# **Coalbed Methane Stream Depletion Assessment Study – Northern San Juan Basin, Colorado**

**State of Colorado Department of Natural Resources,  
Division of Water Resources and the Colorado Oil  
and Gas Conservation Commission**

**S.S. PAPADOPULOS & ASSOCIATES, INC.  
Boulder, Colorado**

The report dated February 2006 prepared by S.S. Papadopoulos & Associates, Inc. is provided for public review and comment. This study was a joint effort by the Colorado Oil and Gas Conservation Commission (“COGCC”), the Colorado Geological Survey (“CGS”) and the State Engineer’s Office Division of Water Resources (“DWR”). These agencies are part of the Colorado Department of Natural Resources (“DNR”).

Figure 5.5. Probable Fruitland Formation Springs and Seeps

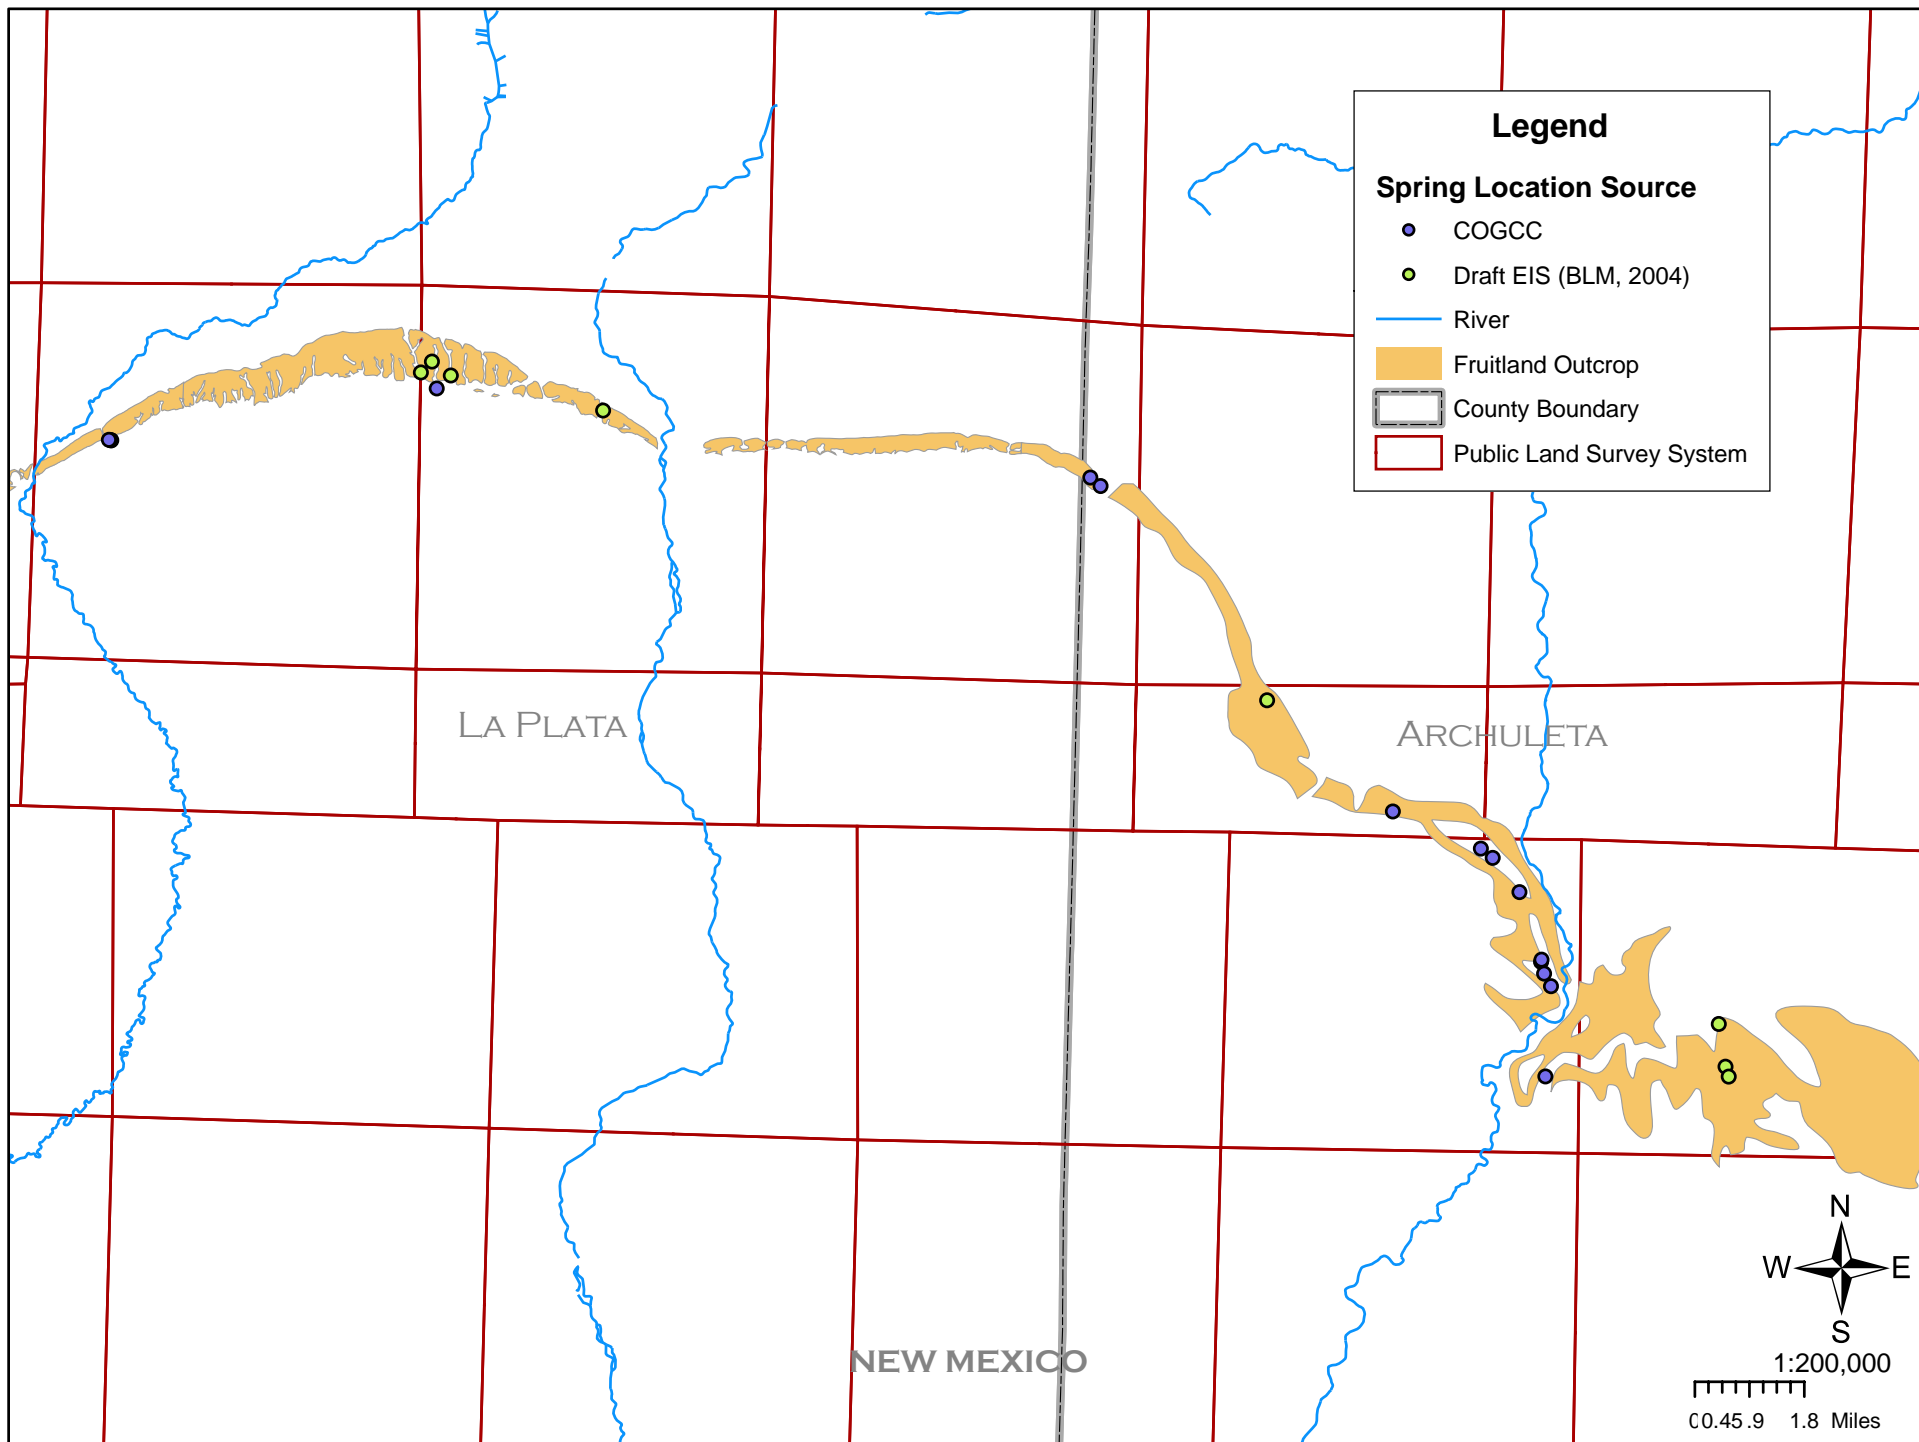
33. Figure 5.2 – Untitled.
34. Figure 5.5 – If one assumes that downbasin production is draining the Fruitland Formation, then spring flows at the highest elevations of the outcrop should be greatly diminished or nonexistent. Perhaps the existence of these springs (as indicated on this figure) is an indication of a lack of downbasin connectivity.

34. Figure 5.5: Logic behind comment is unclear. The report does not state that downbasin production is draining the Fruitland Formation. SSP&A calculated an extremely small impact to the outcrop and stream areas; these impacts do not imply that springs would be greatly

**Figure 5.6. Equivalent Head Measurements**

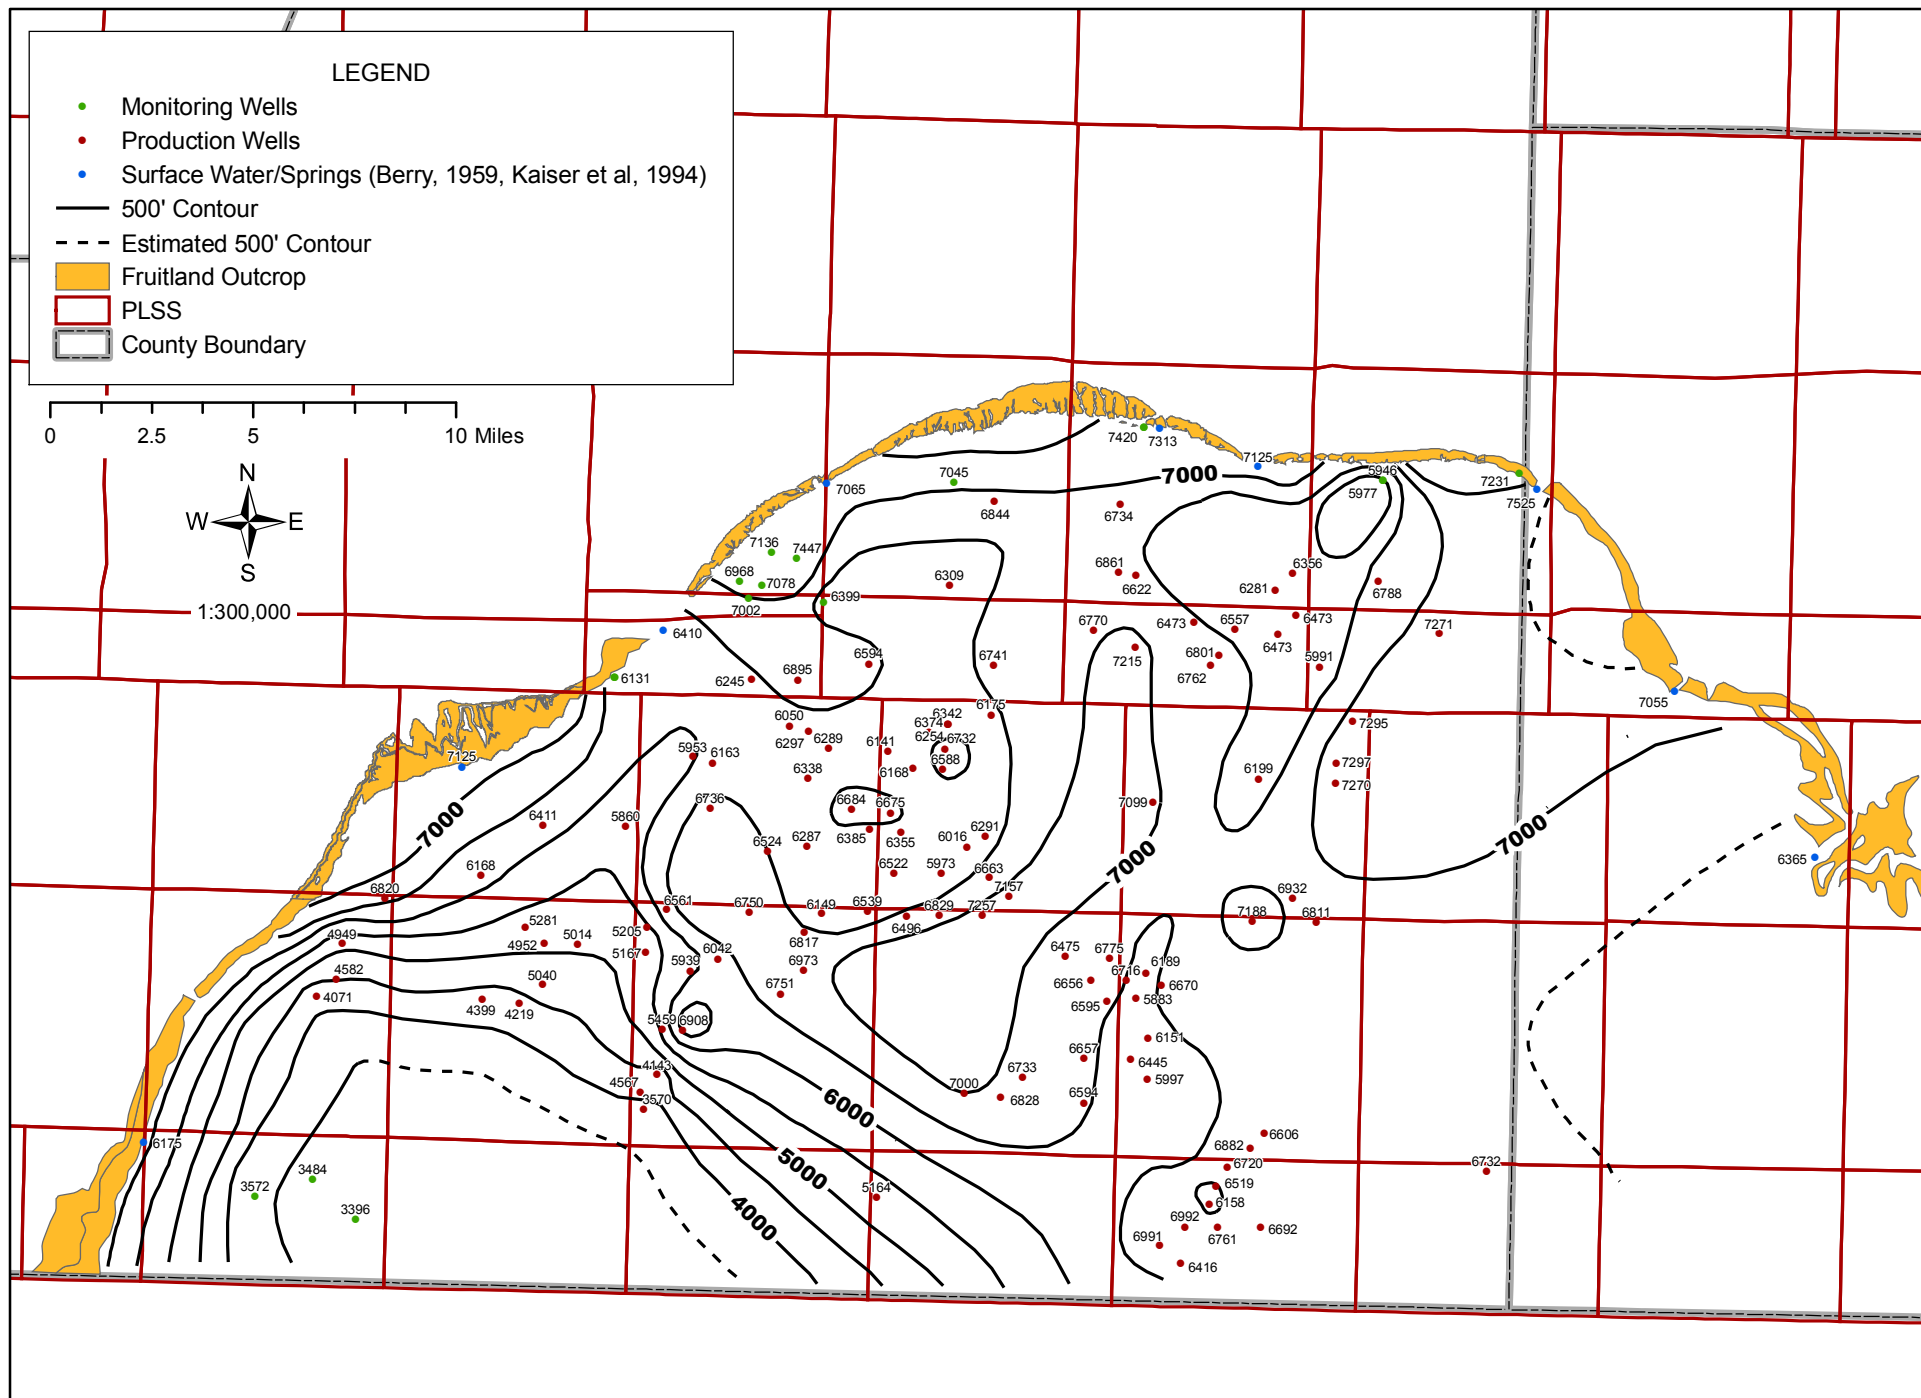
12. Page 34, 1<sup>st</sup> Line – Reference is made to Figure 5.7, but we were unable to find this figure. It would seem that the reference should be to Figure 5.6.

12. The reviewer correctly notes that the cited figure should be Figure 5.6.
13. The reviewer misunderstands the analysis. SSP&A stated that evaluation of site-specific impacts is not the goal of the study. That being given as a restriction on study goals, it is not to say that where long-term pressure data are available, they wouldn't be utilized to assist in characterizing basin conditions.

Figure 6.2. Potential Future Fruitland CBM Well Locations Used in Glover Analysis

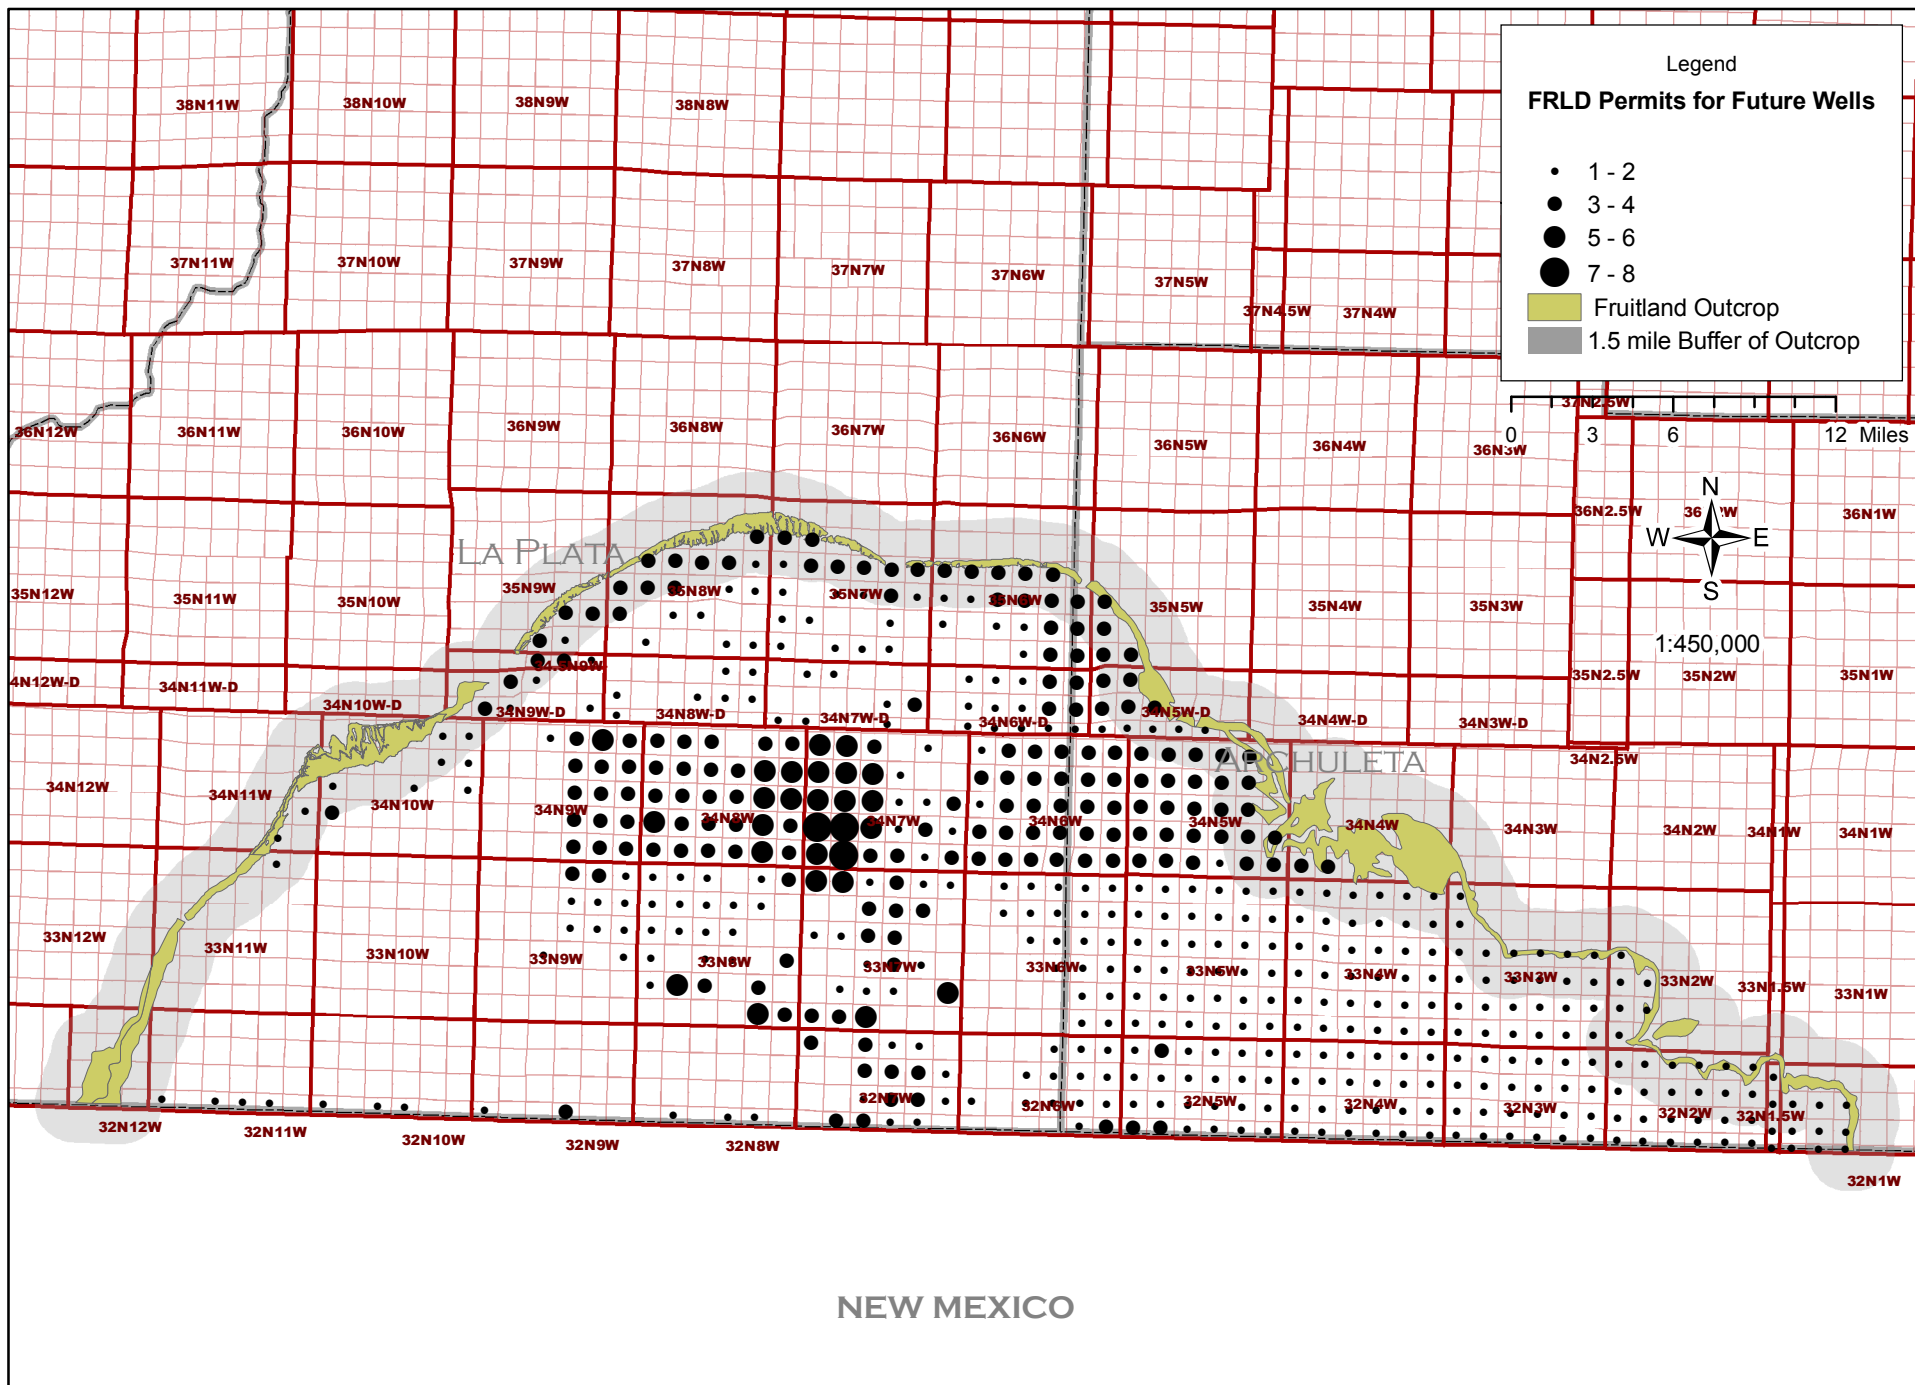
35. Figure 6.2 – This is one of the very few plan views of the basin that includes Township and Range numbers. Inclusion of this information on each figure would help to orient the reader (particularly Figure 6.1).
